SERVICE BULLETIN

N° **139-444**

REV. : C - June 28, 2018

ATA 78 - EXHAUST DUCTS AND REAR FIREWALL RETROMOD

Figure 11

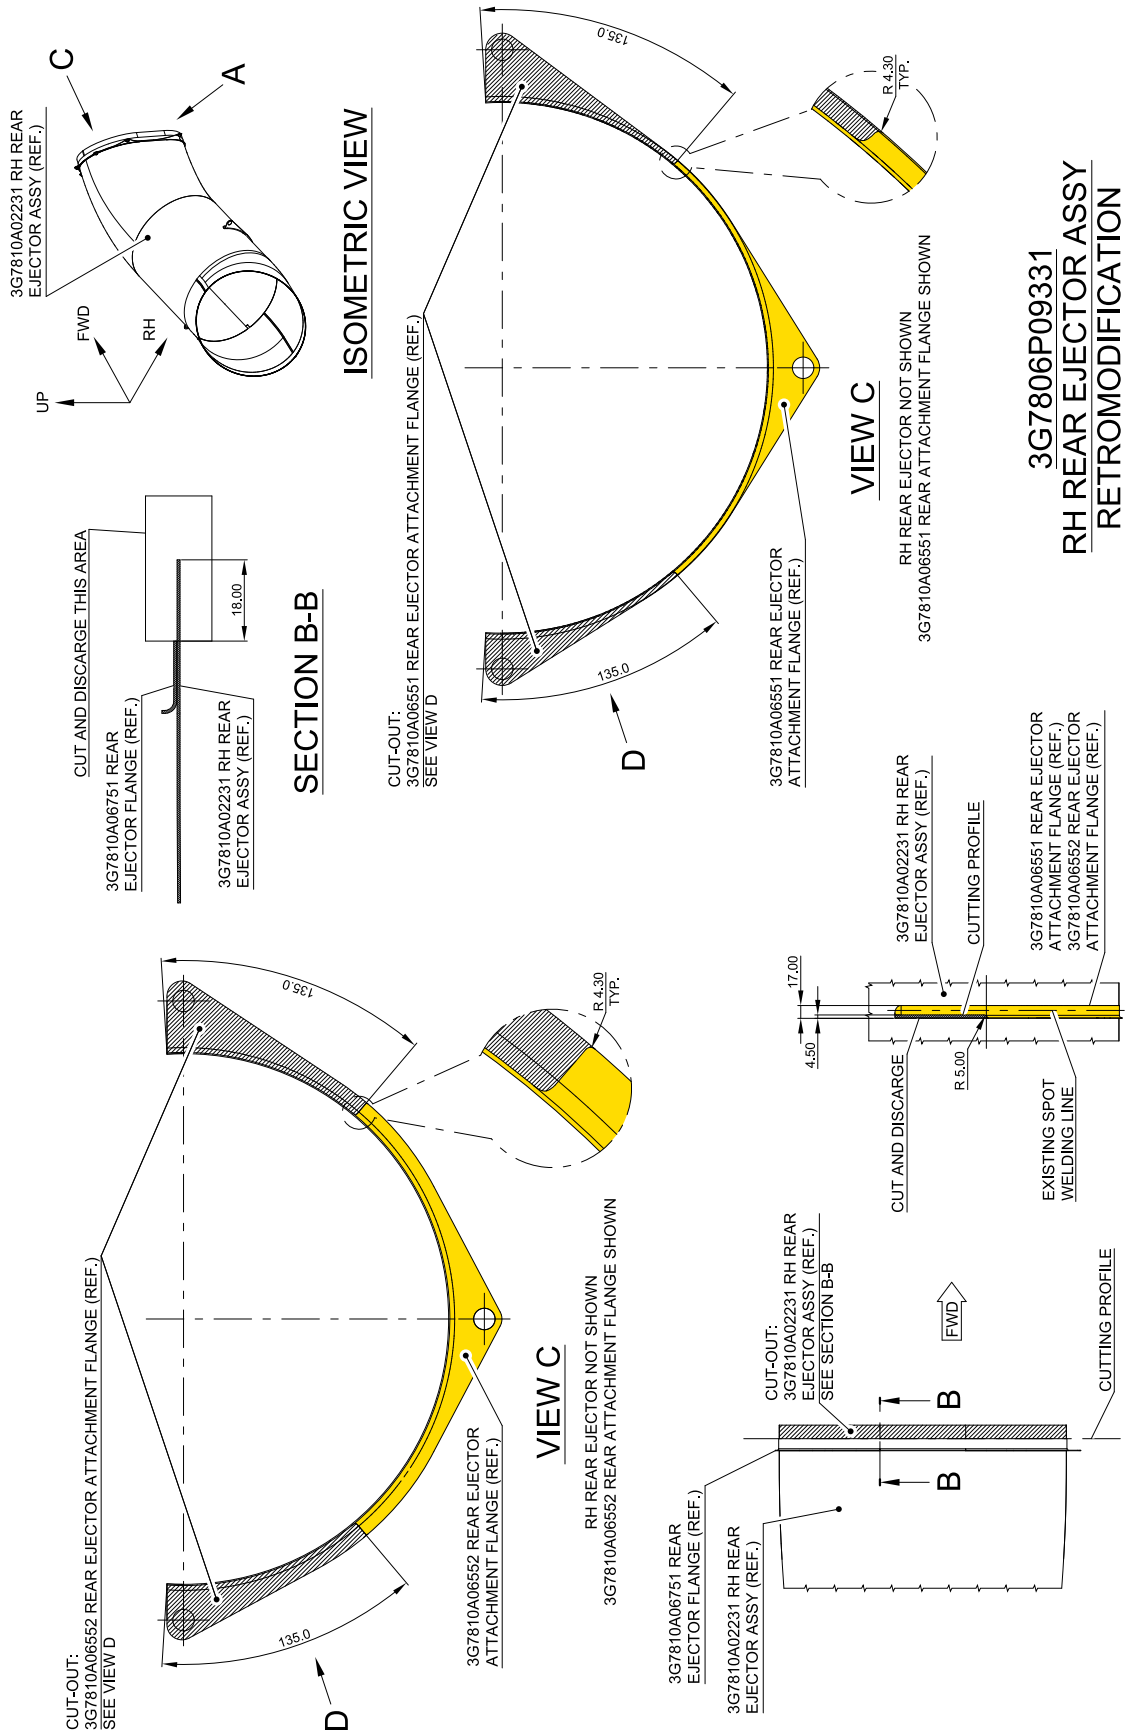
- 3.1 With reference to Figure 11 view A and section B-B, perform indicated cut out of RH rear ejector assy P/N 3G7810A02231.

- 3.2 With reference to Figure 11 view C and view D, perform cut out of rear ejector attachment flange P/N 3G7810A06552 or P/N 3G7810A06551 along the cutting profile shown.

- 3.3 With reference to 11 view C and view D, remove the portion of rear ejector attachment flange.
- 3.4 With reference to Figure 12 and Figure 14, countermark the position of n°118 rivet holes on the LH rear ejector assy P/N 3G7810A02231.

Figure 12

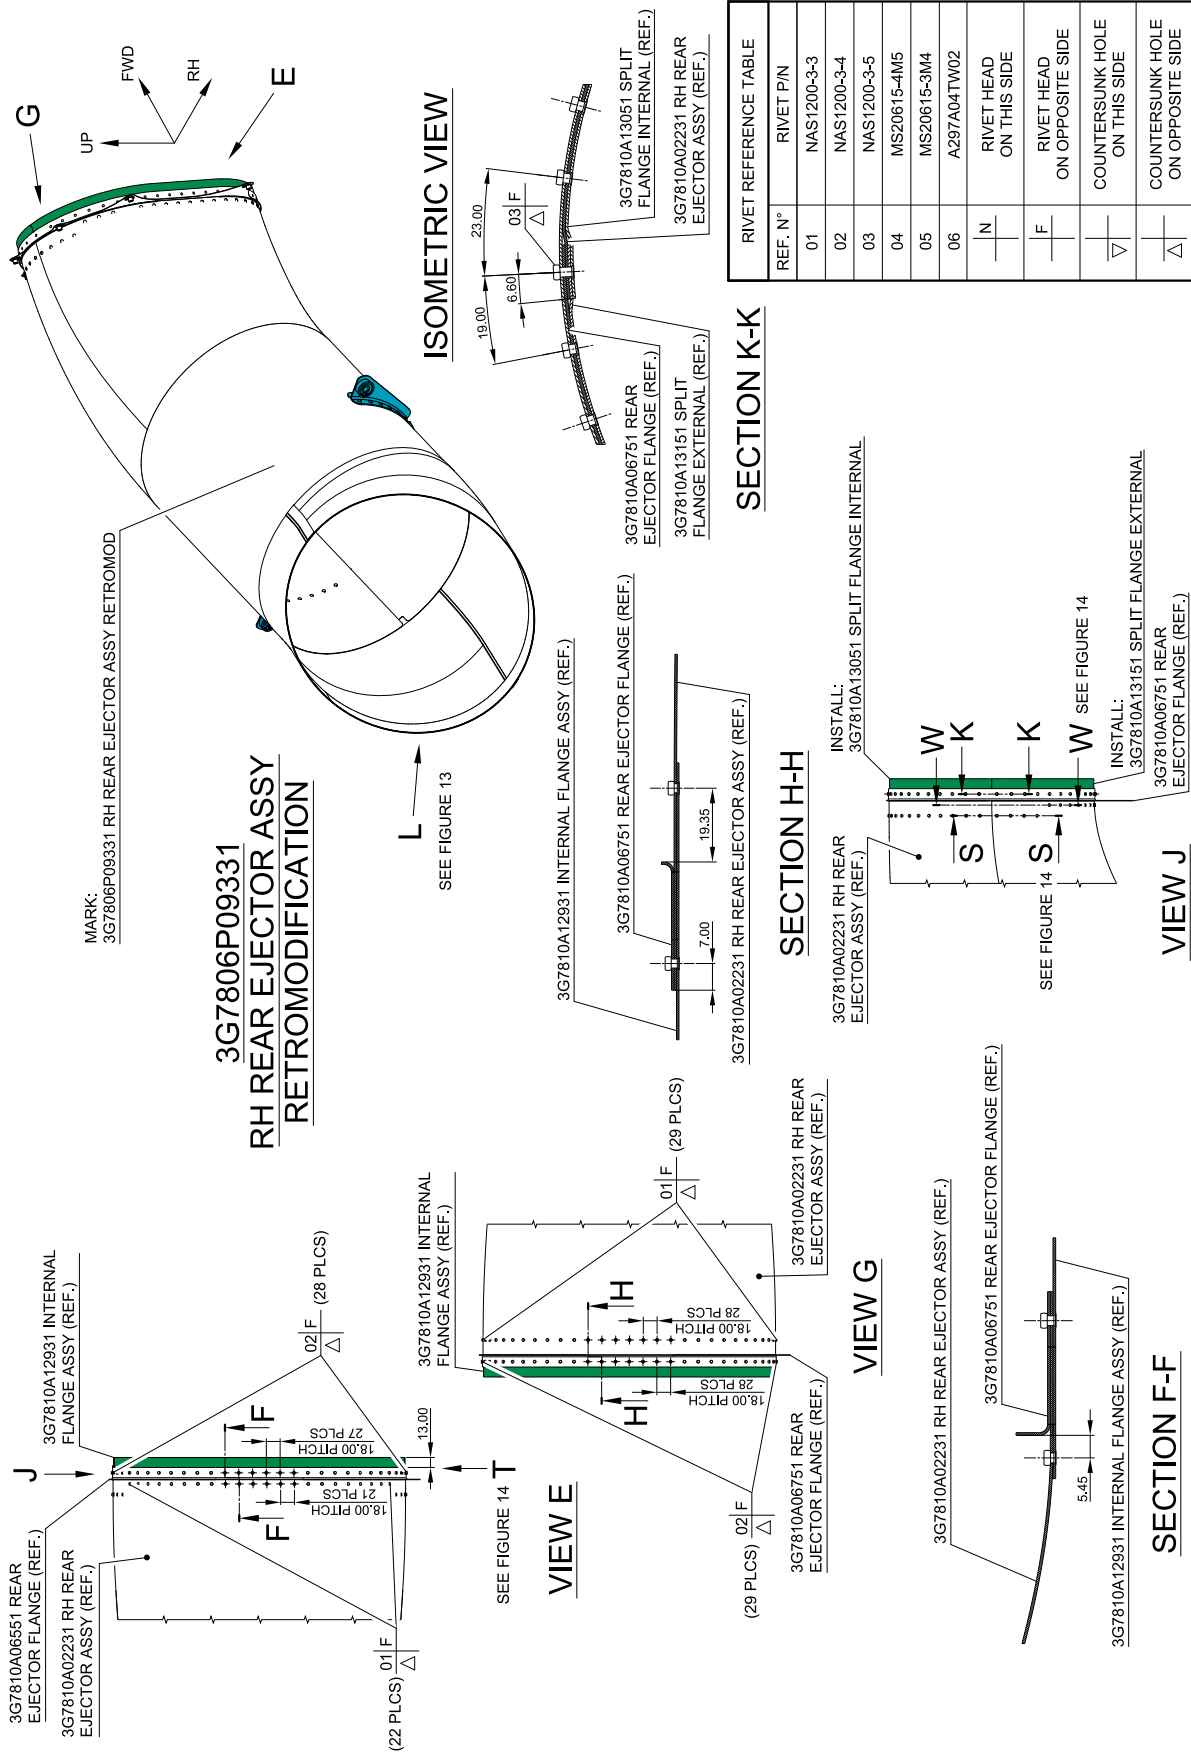
- 3.5 With reference to Figure 12 and Figure 14, drill n°118 rivet holes $\varnothing 2.36 \div 2.62$ through the LH rear ejector assy P/N 3G7810A02231, in previously marked positions.

- 3.6 With reference to Figure 12 and Figure 14, temporarily locate n°1 split external flange P/N 3G7810A13151 and n°1 split internal flange P/N 3G7810A13051. Countermark the position of n°118 rivet holes on the two flanges.

- 3.7 With reference to Figure 12 and Figure 14, drill n°118 rivet holes $\varnothing 2.36 \div 2.62$ through the two flanges, in previously marked position.

- 3.8 With reference to Figure 12 and Figure 14, install together install n°1 split external flange P/N 3G7810A13151 and n°1 split internal flange P/N 3G7810A13051, by means of n°57 rivets P/N NAS1200-3-3, n°59 rivets P/N NAS1200-3-4 and n°2 rivets P/N NAS1200-3-5.

- 3.18 With reference to Figure 12, mark P/N 3G7806P09331 on the reworked RH rear ejector assy by means of an indelible pen.
4. With reference to Figure 37, if the rear exhaust aft attachment flange P/N 3G7810A06551 or P/N 3G7810A06552 has been subject to temporary repair procedure applied as part of dedicated in-service maintenance action, and if during the application of the retro-modification 3G7806P09331 the removal of such temporary repairs related hardware leaved unused rivet holes in the exhaust duct, perform the following procedure:

Figure 13

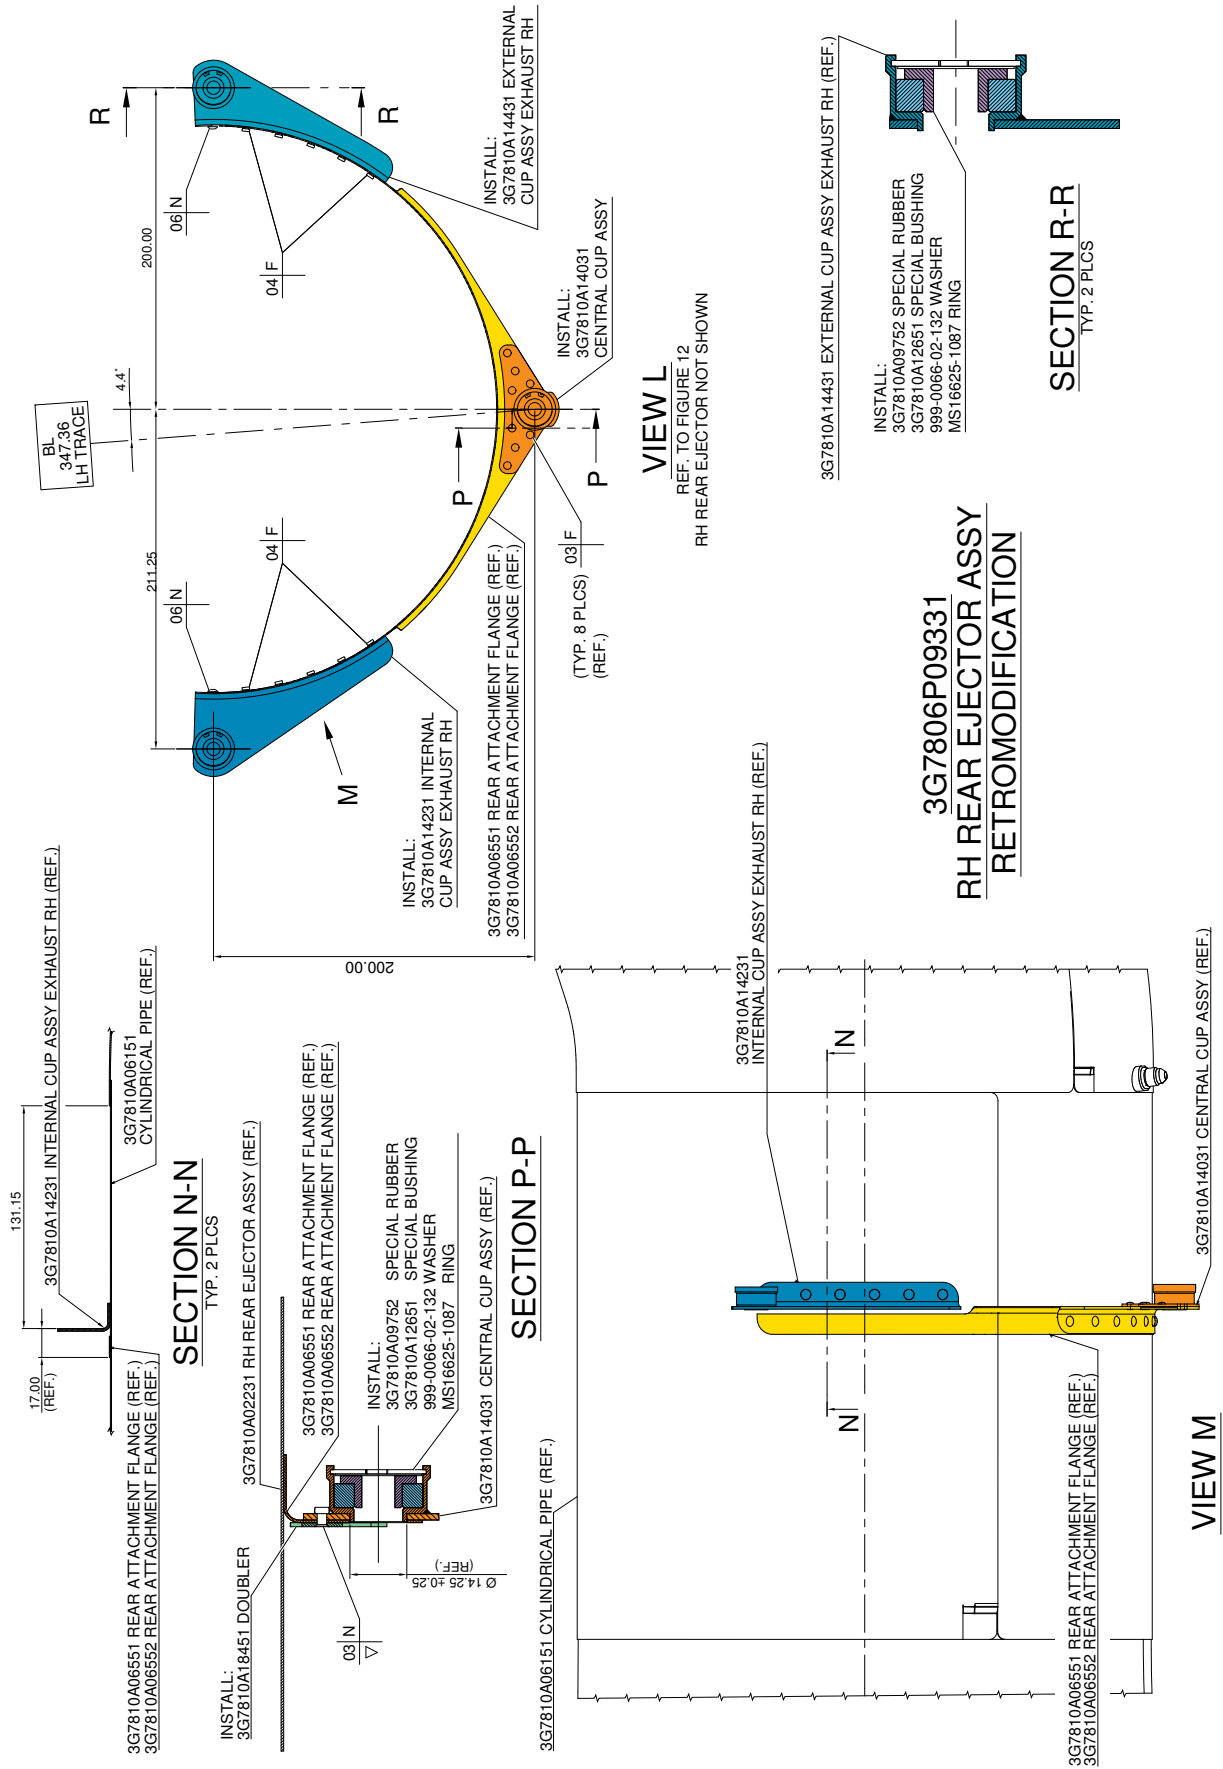
- 3.9 With reference to Figure 13 view L and section P-P, temporarily locate central cup assy P/N 3G7810A14031 and doubler P/N 3G7810A18451 and countermark position of n°8 rivet holes in the rear attachment flange.
- 3.10 With reference to Figure 13 view L, drill n°8 rivet holes $\varnothing 2.36 \div 2.62$ in previously marked positions.

- 3.11 With reference to Figure 13 view L and section P-P, install central cup assy P/N3G7810A14031 and doubler P/N 3G7810A18451 by means of n°8 rivet P/N NAS1200-3-5.
- 3.12 With reference to Figures 40 and 41, perform the rear right exhaust flange repair P/N 3G7810R00912 as described in the following procedure:
- 3.12.1 With reference to Figure 40, remove the indicated area.
- 3.12.2 With reference to Figure 41, install the central flange RH assy P/N 3G7810A18831 by means of n°7 rivets P/N MS20615-3M4.

- 3.13 With reference to Figure 13 section P-P, install in the central cup assy one special rubber P/N 3G7810A09752, one special bushing P/N 3G7810A12651, one washer P/N 999-0066-02-132 and one ring P/N MS16625-1087.
- 3.14 With reference to Figure 13 view L and section N-N, temporarily locate external cup assy exhaust RH P/N 3G7810A14431 and internal cup assy exhaust RHP/N 3G7810A14231, and countermark position of n°12 rivet holes in the RH rear ejector.

- 3.15 With reference to Figure 13 view L, drill n°12 Ø 3.18 ÷ 3.43 rivet holes in previously marked position through RH rear ejector.
- 3.16 With reference to Figure 13 view L, install external cup assy exhaust LH P/N 3G7810A14431 and internal cup assy exhaust RH P/N 3G7810A14231 by means of n°10 rivets P/N MS20615-4M5 and n°2 rivets P/N A297A04TW02.

- 3.17 With reference to Figure 13 section R-R, install in the external and internal cup assy exhaust LH and RH n°2 special rubbers P/N 3G7810A09752, n°2 special bushings P/N 3G7810A12651, n°2 washers P/N 999-0066-02-132 and n°2 rings P/N MS16625-1087.

Figure 15

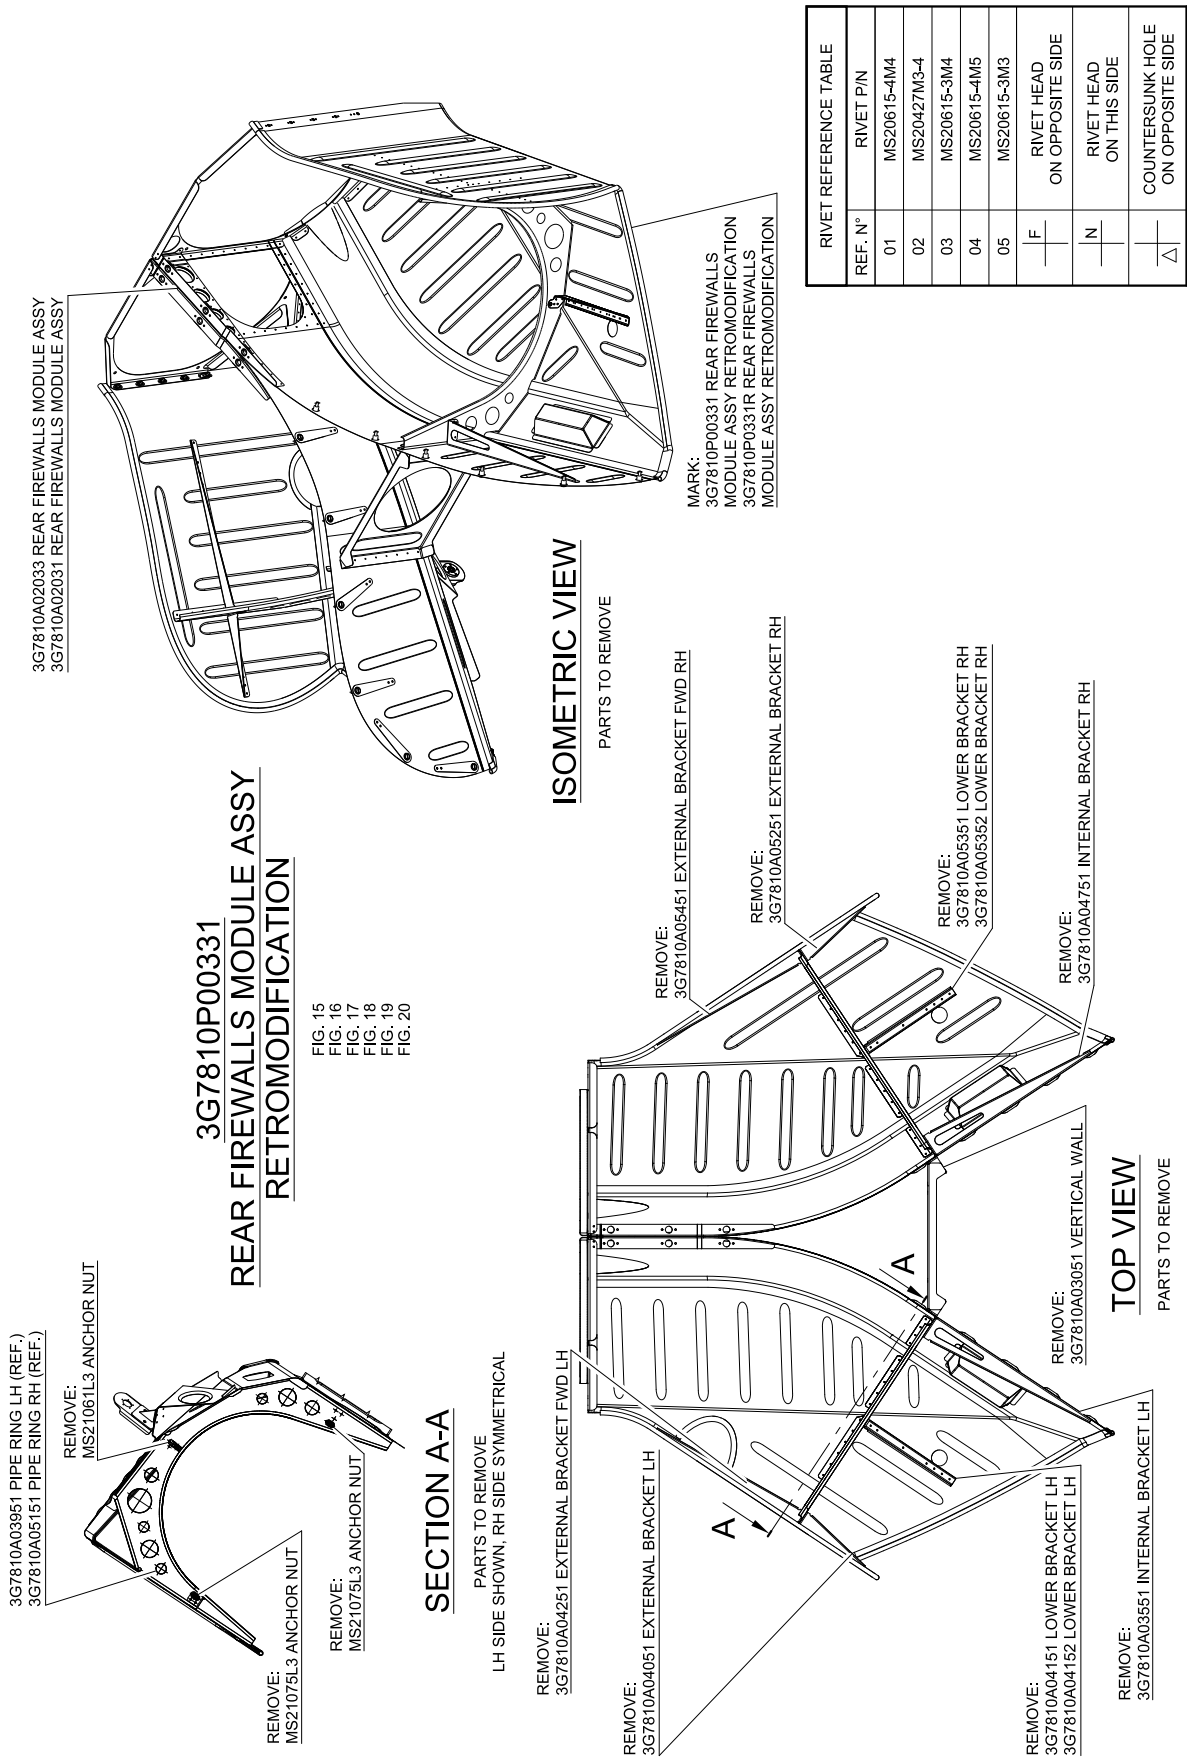
- 2.1 With reference to Figure 15 section A-A, remove and retain for further reuse n°4 anchor nuts P/N M21075L3 and n°2 anchor nuts P/N MS21061L3 from pipe ring LH and RH.

- 2.2 With reference to Figure 15, remove the following items from rear exhaust module drilling out existing rivets:
 - external FWD bracket RH P/N 3G7810A04251.

Figure 16

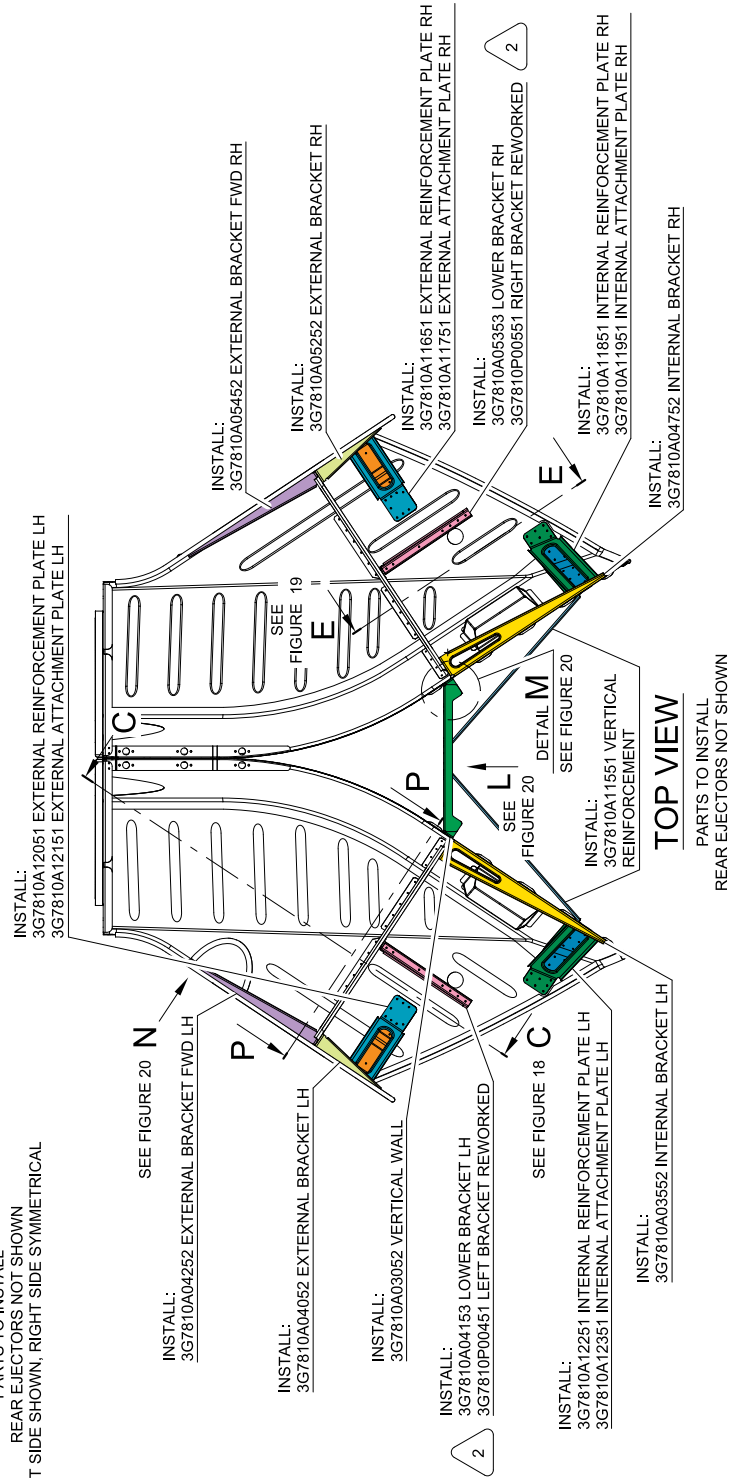
- 2.10 With reference to Figure 16, temporarily locate lower bracket LH P/N 3G7810A04153 and lower bracket RH P/N 3G7810A05353. Countermark position of n°18 rivet holes.

- 2.13 With reference to Figure 16, temporarily locate external bracket LH P/N 3G7810A04052 and external bracket RH P/N 3G7810A05252. Countermark position of n°18 rivet holes.

- 2.16 With reference to Figure 16, temporarily locate internal bracket LH P/N 3G7810A03552 and internal bracket RH P/N 3G7810A04752. Countermark position of n°36 rivet holes.

- 2.19 With reference to Figure 16 section P-P, install n°4 anchor nuts P/N MS21075L3 and n°2 anchor nuts P/N MS21061L3 by means of n°12 rivets P/N MS20427M3-4.
